**Our Ref:** 5611  
**Date:** 11 June 2025  
**To:** RSF Land Projects Pty Ltd  
**C/-** Chase DM

**RE:** Addendum letter for s4.55 mod changes to approved subdivision development application (DA 210293) at Lot 1 DP32236, at 2155 Sutton Road, Sutton, NSW, 2620.

**Attachment A – Site Plan**

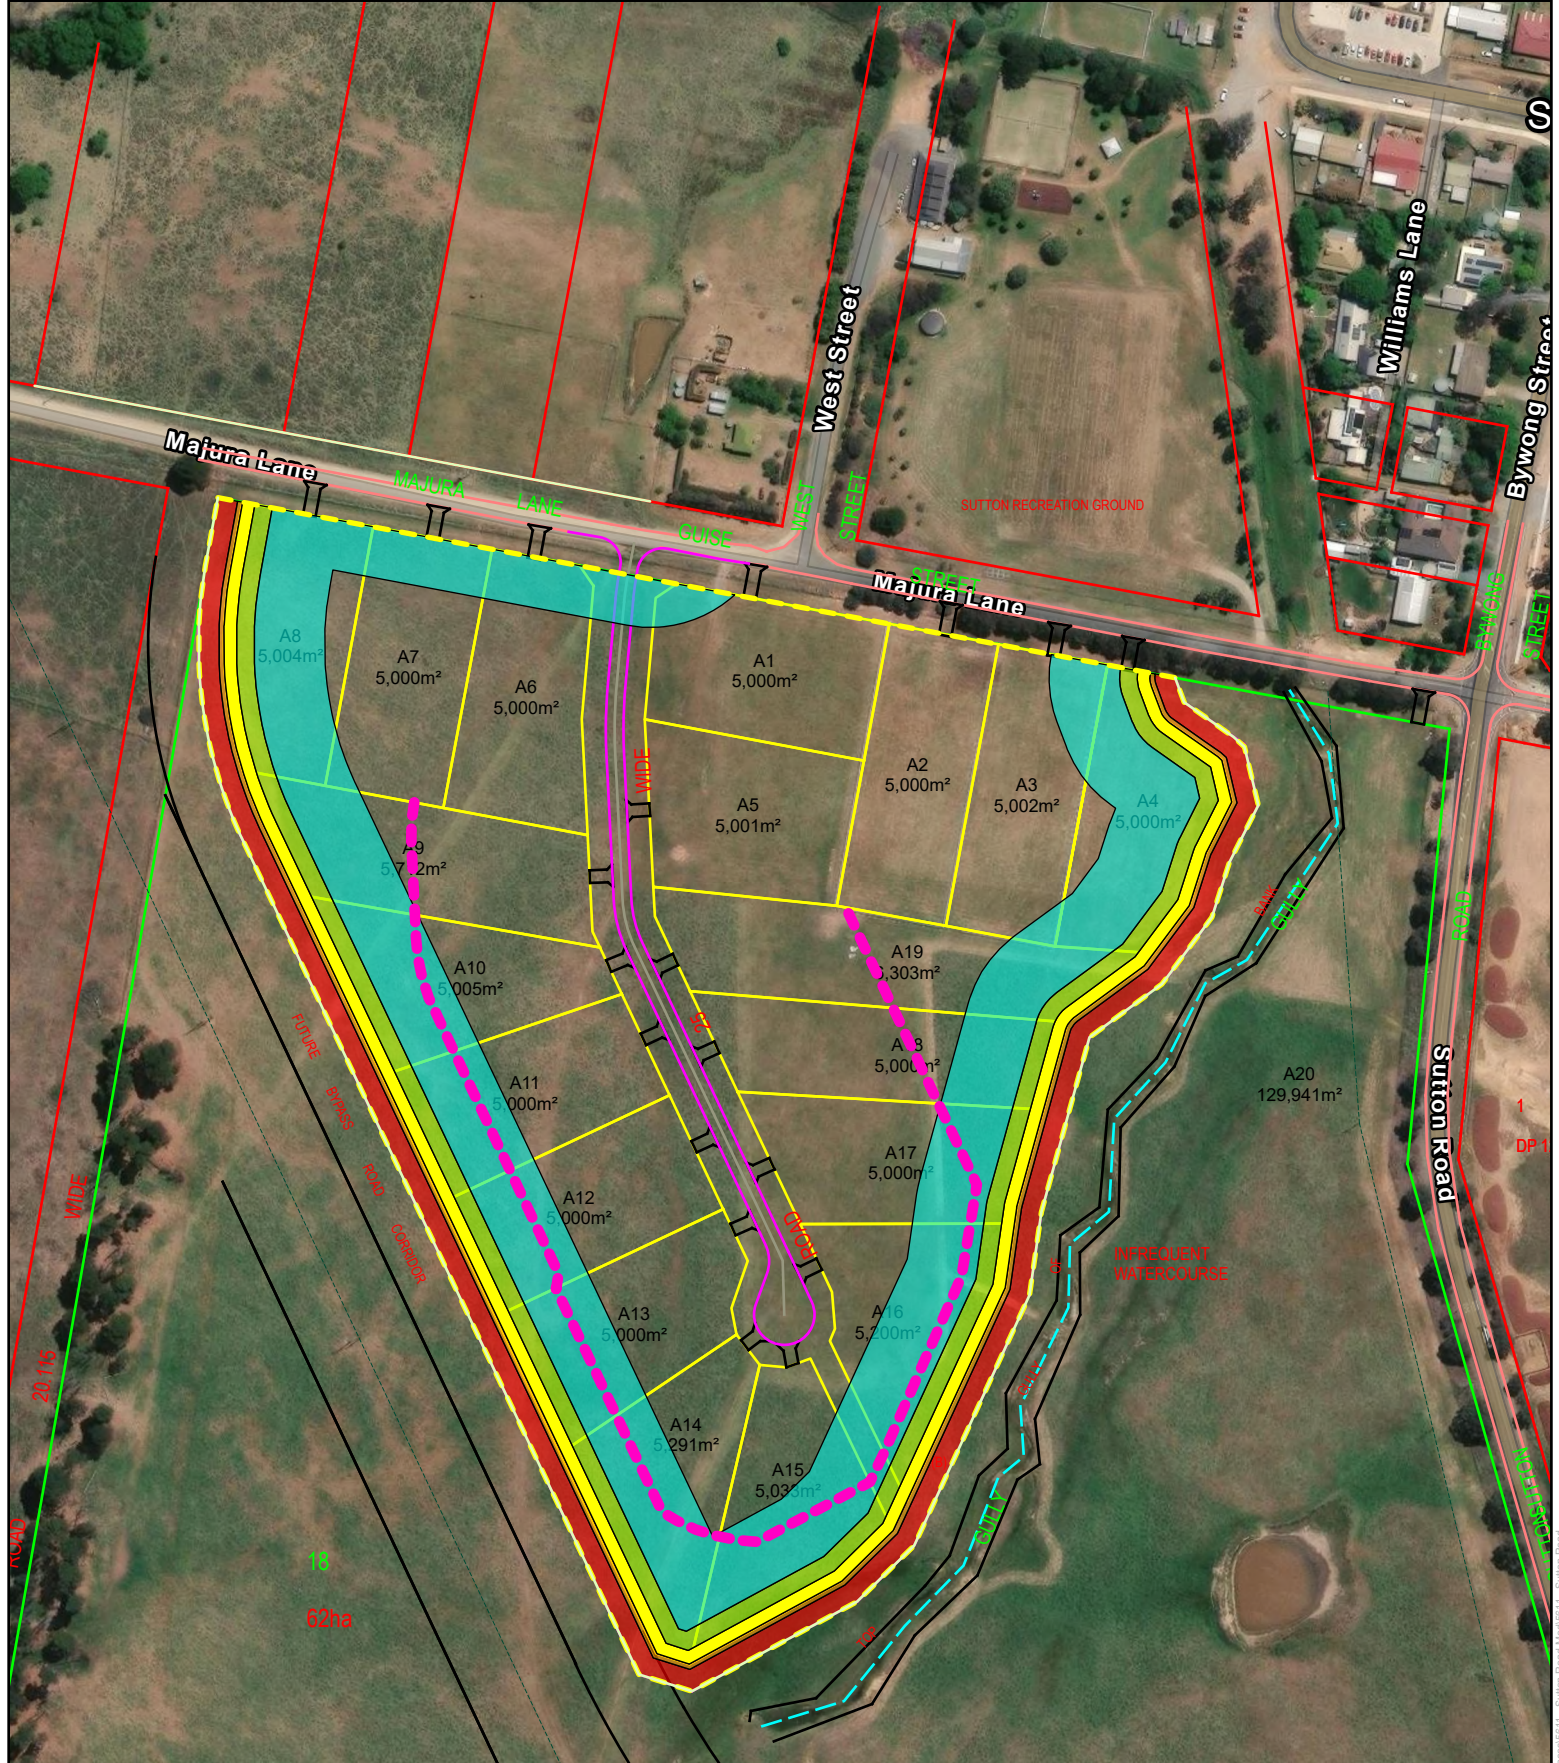
The proposal (**Attachment A**) is to modify the approved rural residential subdivision consent (DA 210293) by:

- *Increase from 17 to 19 x R2 Zoned Lots by shortening the main cul-de-sac and by averaging the developable area over all lots; and*
- *Subdivision of the c.62ha residual R1 land into 1 x c.13ha and 1 x c.48ha lots Land along the line of the Proposed Sutton Bypass.*
